UNITED STATES PATENT AND TRADEMARK OFFICE

APPLICATION NO.	FILING DATE	FIRST NAMED INVENTOR	ATTORNEY DOCKET NO.	CONFIRMATION NO.
10/617,139	07/11/2003	Takafumi Suzuki	040894-5941	1415
9629	7590	08/02/2007	EXAMINER	
MORGAN LEWIS & BOCKIUS LLP			PILKINGTON, JAMES	
1111 PENNSYLVANIA AVENUE NW			ART UNIT	PAPER NUMBER
WASHINGTON, DC 20004			3682	
MAIL DATE		DELIVERY MODE		
08/02/2007		PAPER

DETAILED ACTION

From Figure 3 of Takahashi

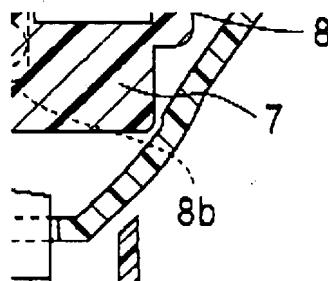
Re clm 1, Takahashi discloses a lever apparatus comprising:

- A lever (3);
- A cover part (attached to 3) disposed on a base end portion of the lever (3), which includes a spherical-shaped outer surface and a thickness-reducing recessed portion formed on an inner surface side thereof (see Figure below);
- A mounting part (7) fixedly projecting from the inner surface of the cover part;
- A pair of fitting recessed portions (7a) formed in opposed side portions of the mounting part (7) outside of the cover part (attached to 3)
- A pair of shaft portions (8b)
- a lever support structure (8) including the pair of shaft portions (8b) with which the pair of fitting recessed portions are respectively rotatably fitted.

Takahashi does not disclose that the mounting part and the lever are formed monolithically.

Re clm 2, Takahashi discloses a pair of openings (7a) respectively formed in peripheries of associated shaft portions. Character 7a is a recess designed to house character 8b see C7-8.

Re clm 3, Takahashi discloses an inserting opening (in between 8e and 8d, see Figure 3) to which the mounting part (7) is inserted is formed in the lever support portion (8), and the pair of shaft portions project toward the inserting opening (8b).

Re clm 4, Takahashi discloses that the lever support portion (8) is configured such that when the mounting part (7) is inserted into the lever support portion (8), the pair of shaft portions (8b) abut the mounting part (7) and wherein the shaft portions (8b) are able to be elastically deformed.
